Giant Mine Remediation Project Environmental Assessment Water Treatment and Management

Alternatives North

Kevin O'Reilly
September 11, 2012

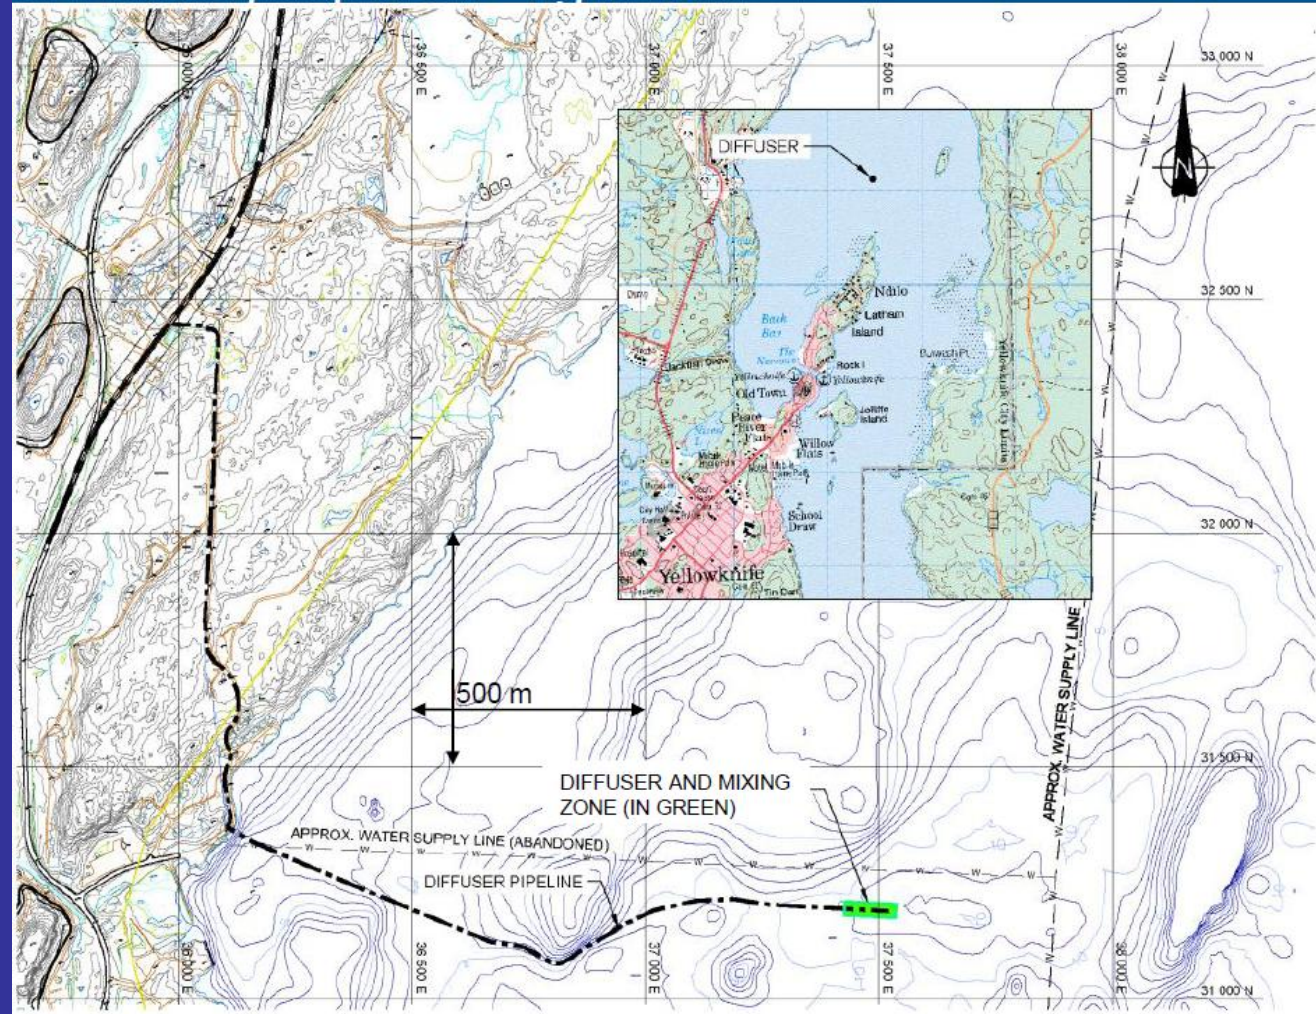
- New water treatment plant a good thing

- Significant changes in discharge timing and location
- Moved from summer discharge into Baker Creek to year-round operation in Back Bay
- No final design for treatment plant
- Ice thinning and water quality issues not resolved
